PROJECT: C-8625 SR 520 West Approach Bridge North Project

SUBJECT: CO # 81 – Delete Facility M

**WASHINGTON STATE
DEPARTMENT OF TRANSPORTATION
CHANGE ORDER**

Contract 8625 Change Order 81 Page 67 of 72 BARRIER PLAN	SHEET 1479 OF 1797 B.A.543
---	--

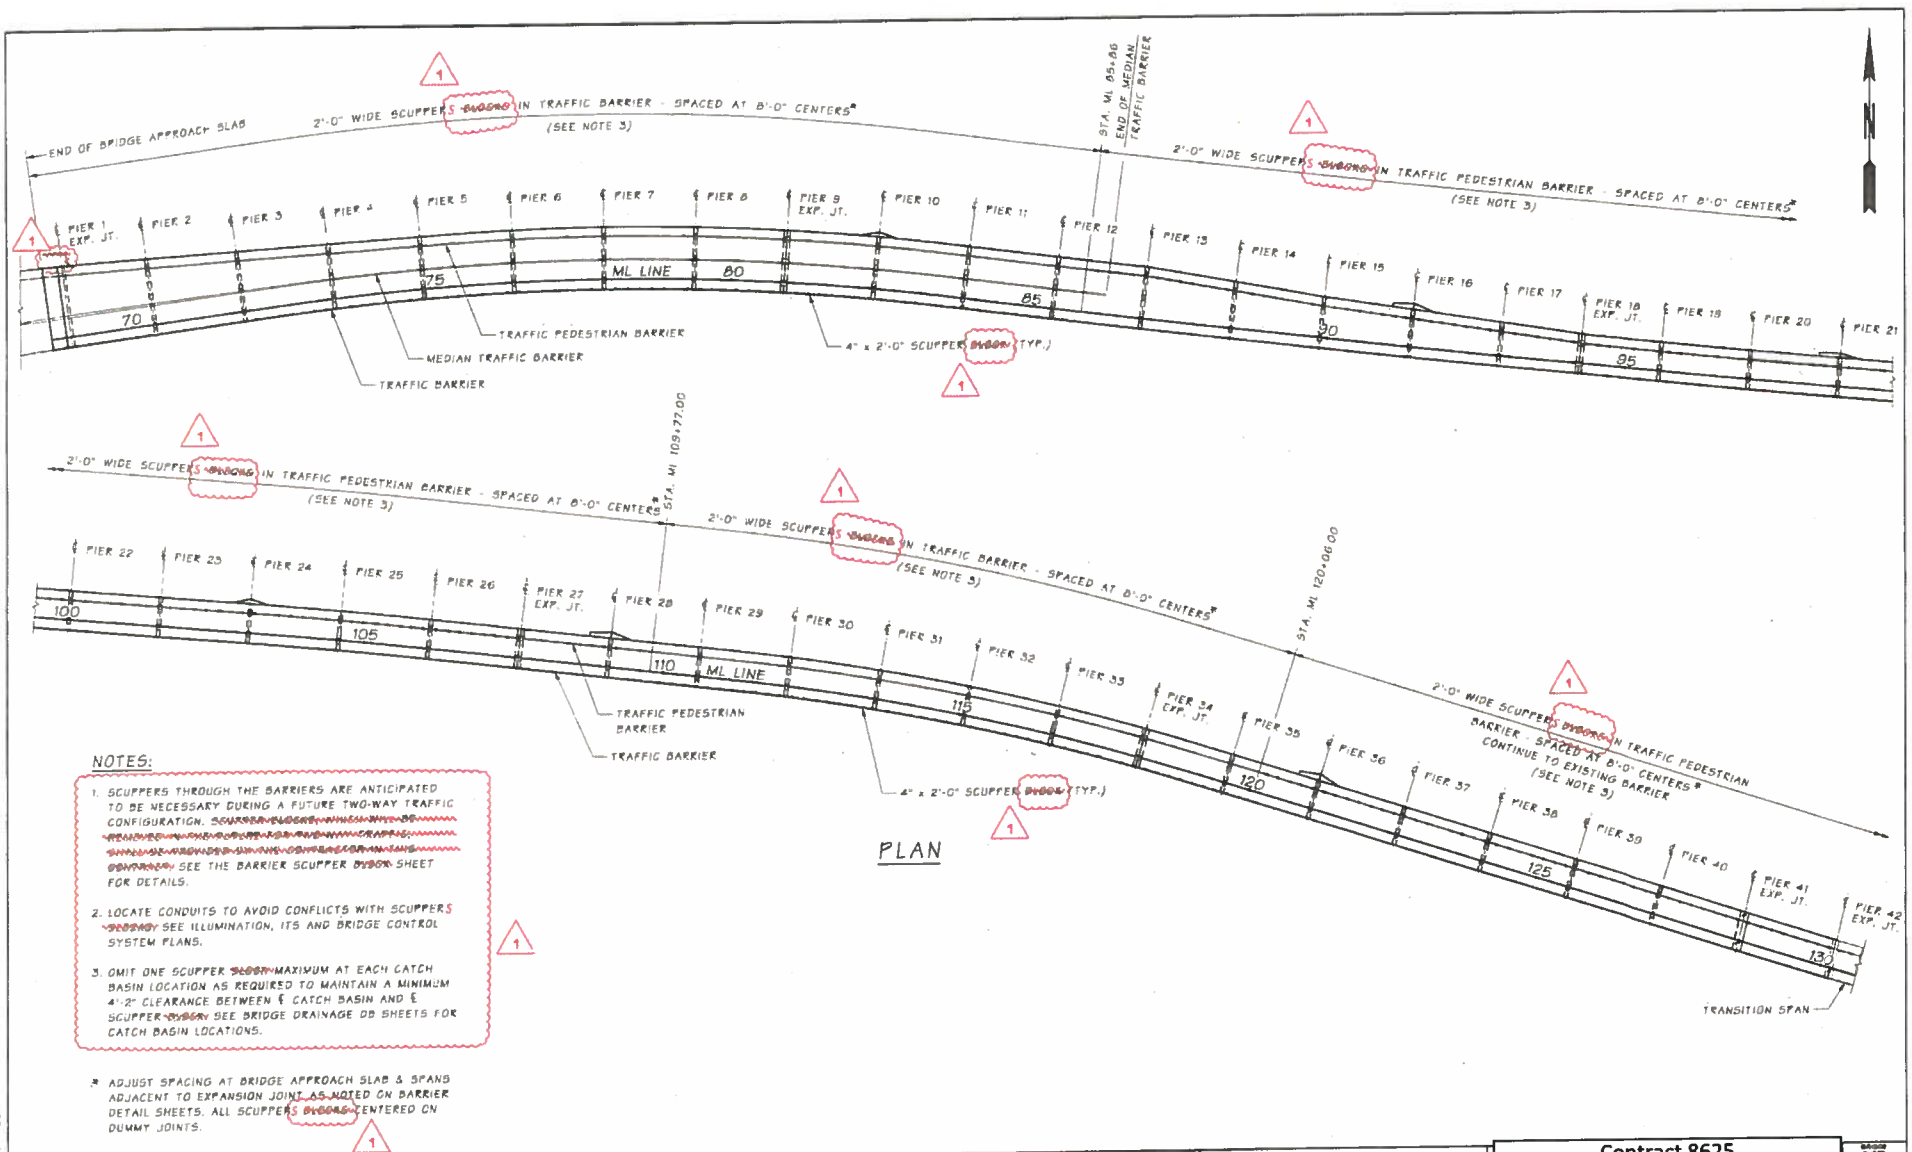
This change order also eliminates Wall 9 and the scupper blocks for concrete barriers on WAEN.

- NOTES:**
- SCUPPERS THROUGH THE BARRIERS ARE ANTICIPATED TO BE NECESSARY DURING A FUTURE TWO-WAY TRAFFIC CONFIGURATION. ~~SCUPPERS THROUGH THE BARRIERS ARE ANTICIPATED TO BE NECESSARY DURING A FUTURE TWO-WAY TRAFFIC CONFIGURATION. SEE THE BARRIER SCUPPER DETAILED SHEET FOR DETAILS.~~
 - LOCATE CONDUITS TO AVOID CONFLICTS WITH SCUPPERS ~~SEE ILLUMINATION, ITS AND BRIDGE CONTROL SYSTEM PLANS.~~
 - OMIT ONE SCUPPER ~~SHOWN~~ MAXIMUM AT EACH CATCH BASIN LOCATION AS REQUIRED TO MAINTAIN A MINIMUM 4'-2" CLEARANCE BETWEEN CATCH BASIN AND SCUPPER ~~SEE BRIDGE DRAINAGE DD SHEETS FOR CATCH BASIN LOCATIONS.~~
